RE: NOMAR CUP Submittal

NOMAR ADDITION 2020

CDM Review Worksheet

A request for Conditional Use Permit (CUP) 20-01 to allow a second-story expansion of the NOMAR building at 104 E. Pioneer Ave. and a 4-unit apartment building at 3916 Main St. This request requires a CUP for more than one building containing a permitted principal use on a lot (HCC 21.18.030 (j)), light manufacturing (HCC 21.18.030 (h)), & for more than 8,000 square feet of building area (HCC 21.18.040 (d)). 104 E. Pioneer Ave. is also known as Lot 8 Tract A, Nils O Svedlund Subdivision Amended, Sec. 20, T. 6 S., R. 13 W., S.M. HM 0540251A. 3916 Main St. is also known as Lot 9 Tract A, Nils O Svedlund Subdivision Amended, Sec. 20, T. 6 S., R. 13 W., S.M. HM 0540251A.

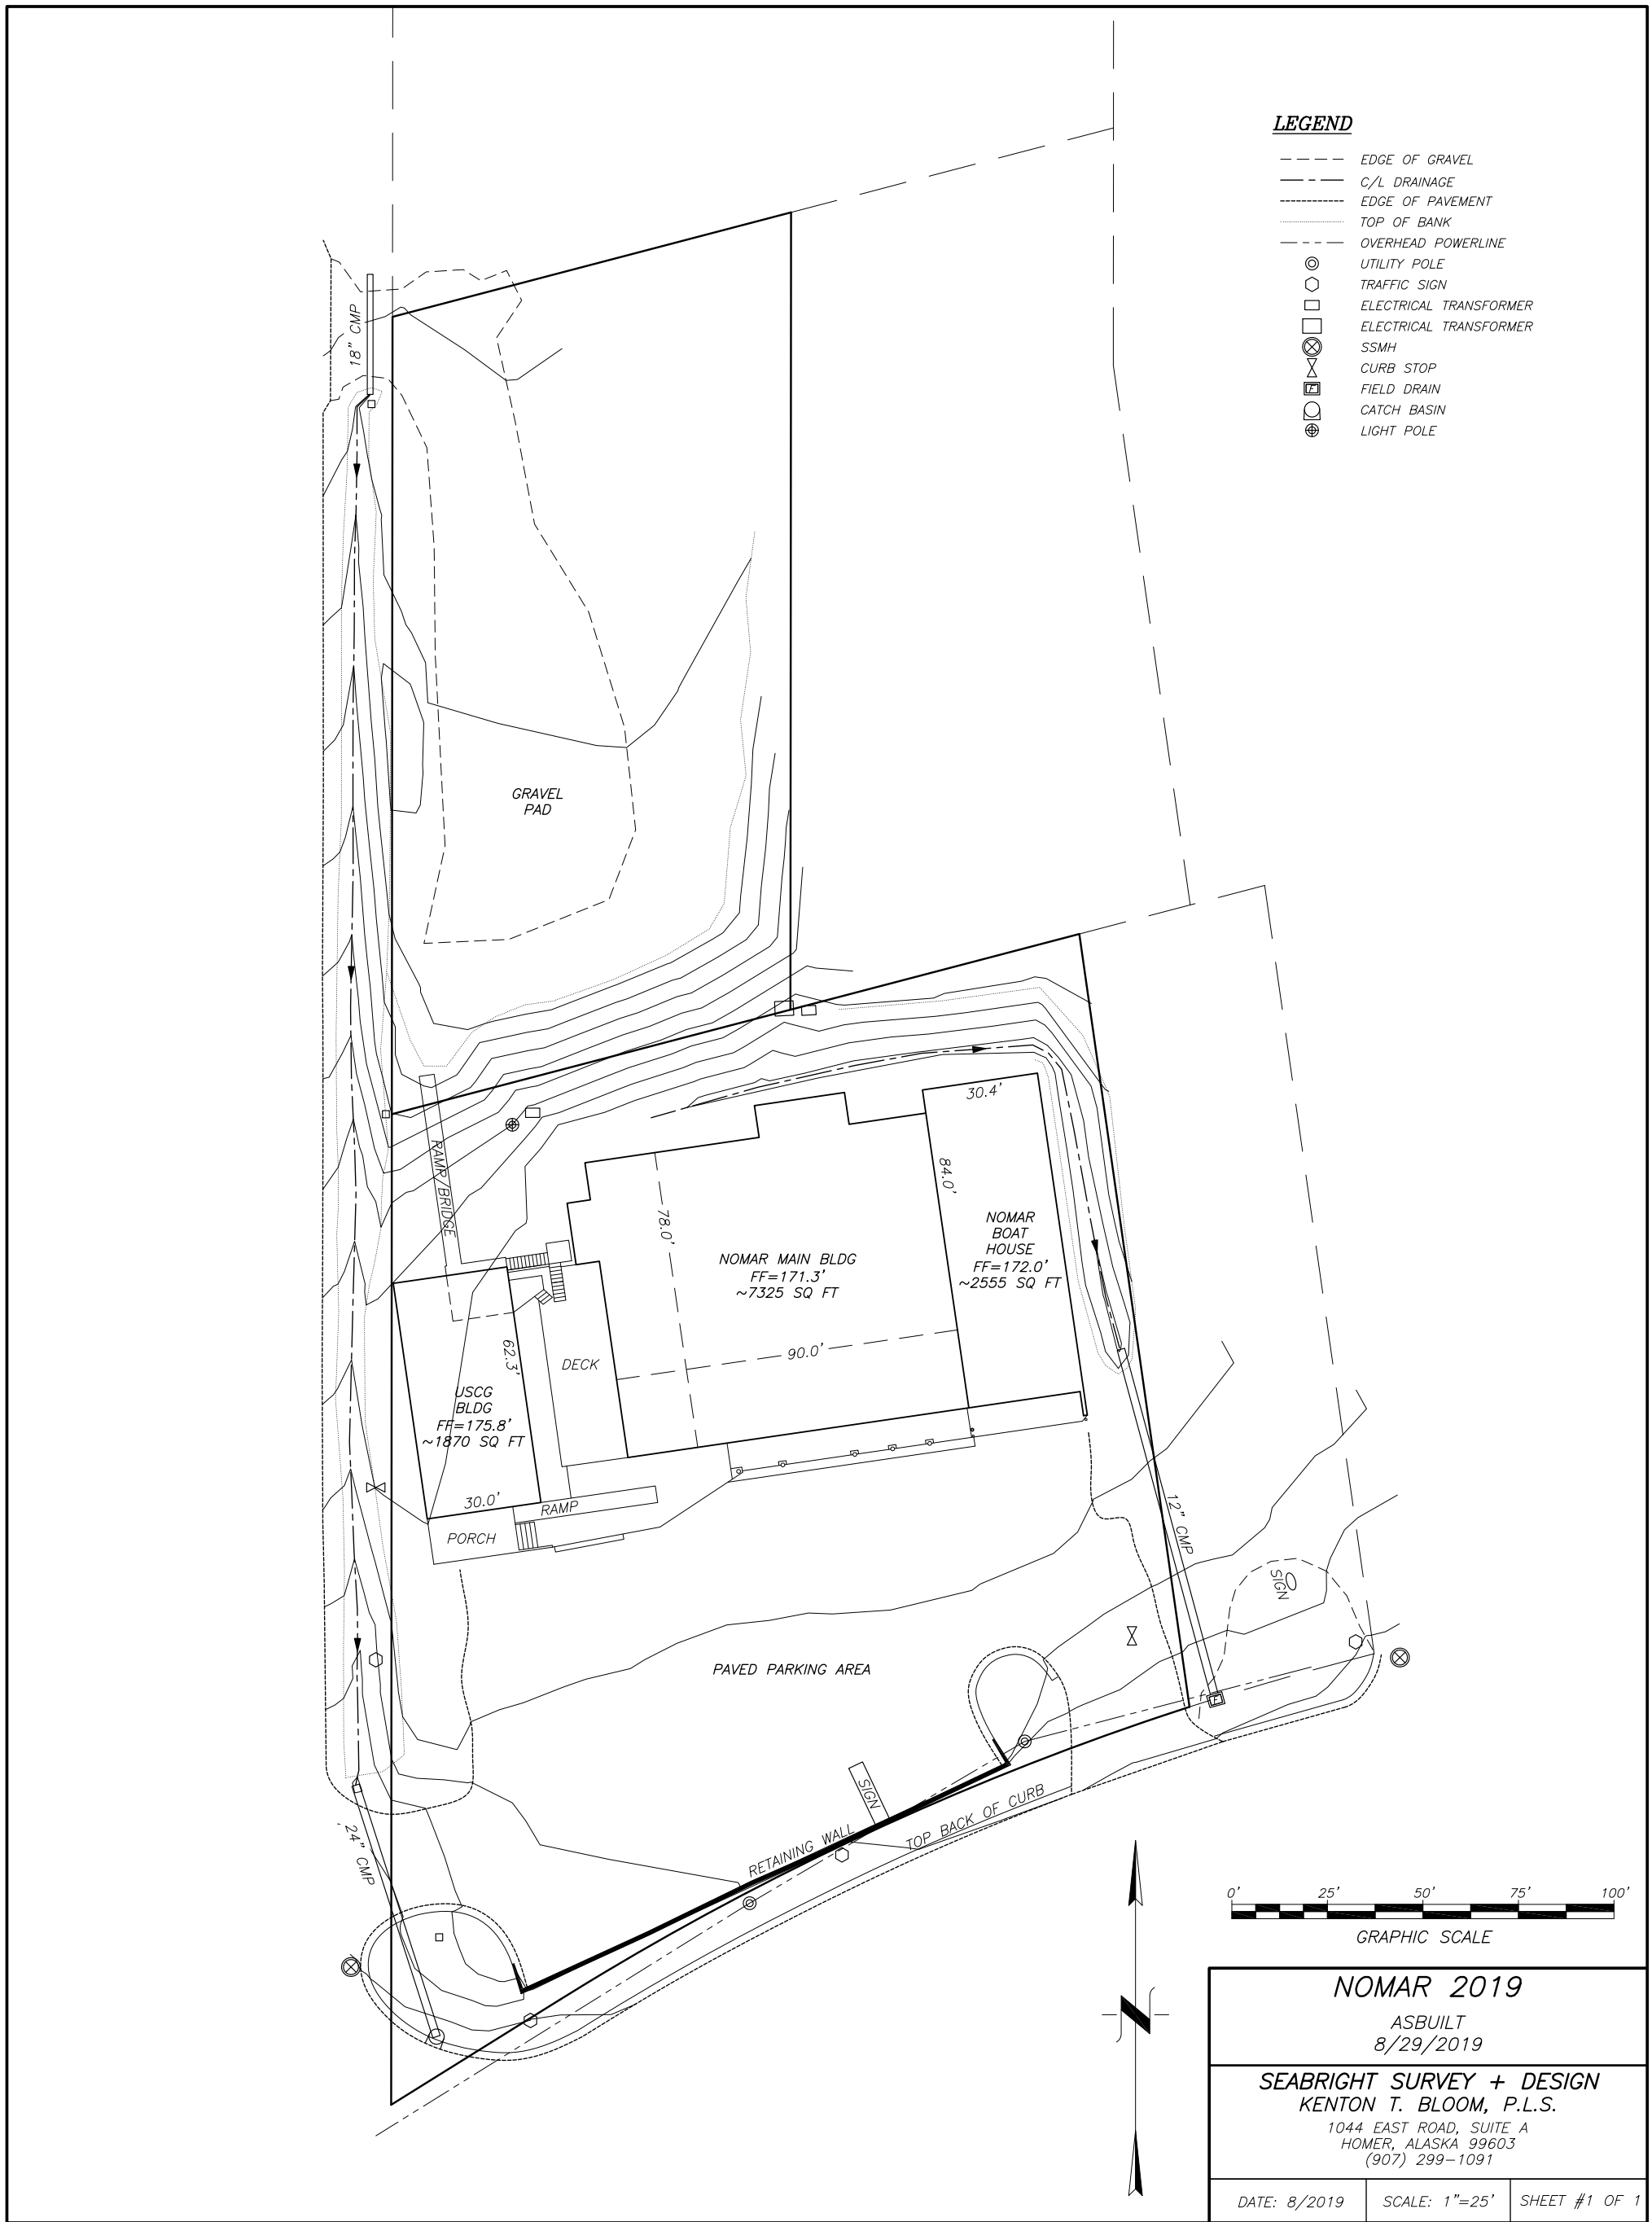
Staff: The applicant will be removing pavement in an area between the main structure and the white two story building. This area will become lawn and provide an outdoor leisure area for the site.

Staff comment: Secondary pathways provide access parking and building entrances at the front and rear of the buildings.

Proposed 2nd story addition looking North from Pioneer Avenue

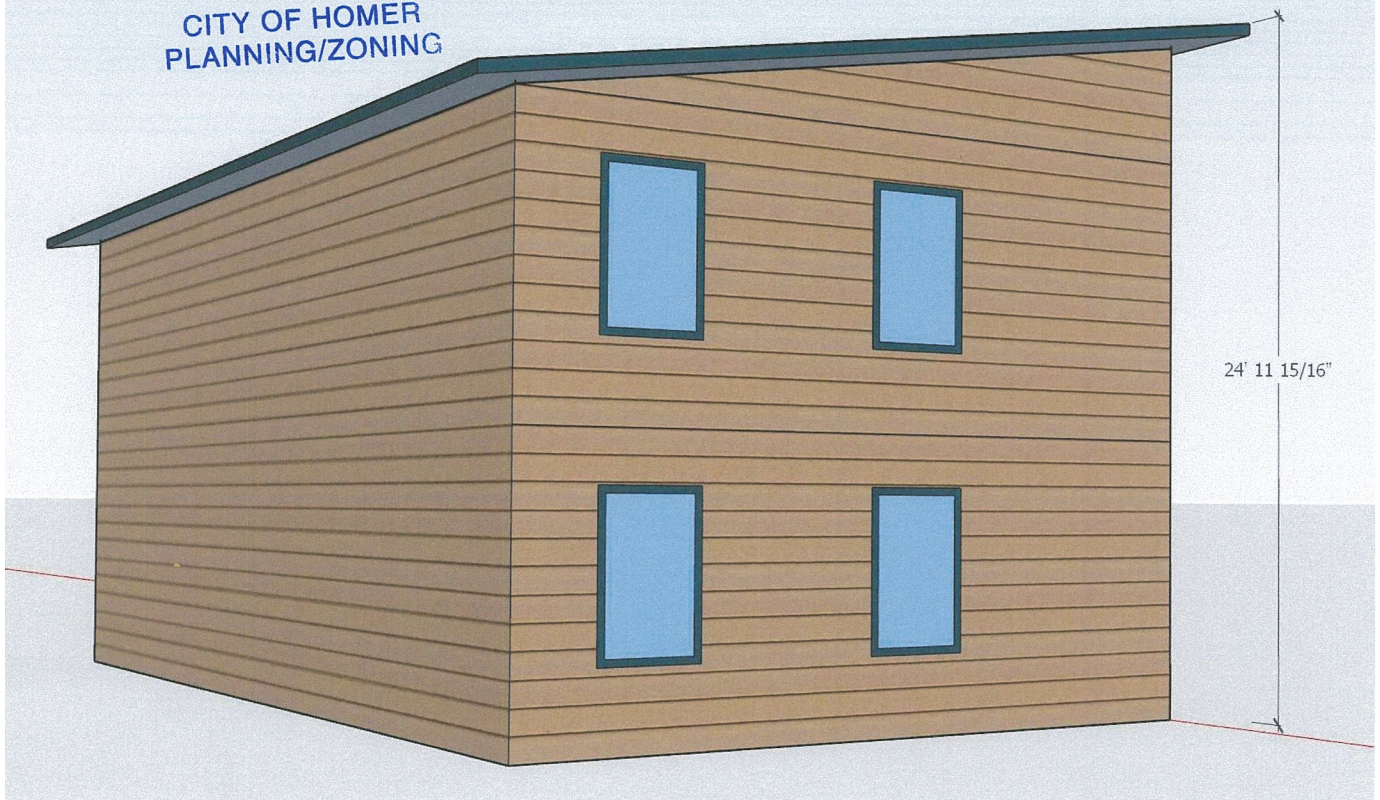
The E Pioneer Ave is a prominent facade. The existing wood beam front entry way and cedar shake style siding will remain. This creates a focal point for the structure. The boat garage currently has a mansard style roof, which is contrary to the CDM. This roof has structural components so it cannot be removed. To remedy the current disjointedness of the structure, the second story addition will create a unified roofline. Although this will be a flat top roof, the applicant feels this design will be in harmony with the mass and scale of other buildings along Pioneer Ave. The Hillas Building at 126 W Pioneer has a slightly wider front and is also a two story structure.

Staff: The prominent facade of the building meet the CDM requirements.

Staff: There are balanced windows in relation to the roofed porch at the main public entrance. On the west side of the building is a large windowed area that cantilevers out, which somewhat balances the boat garage door. The design conforms to solid/void ratios, and the color renderings show the use of different materials and textures to create visual interest.

Staff: The siding and trim simulate traditional quality building materials; the structure will be clad in grey and black tones with wood textured trim. The building will have a modern architecture feel as shown on the renderings.

Staff: Applicant has provided an elevation rendering with planned material colors. The color palette comply with the CDM. Colors are subdued, with an accent colors of blues and greys.
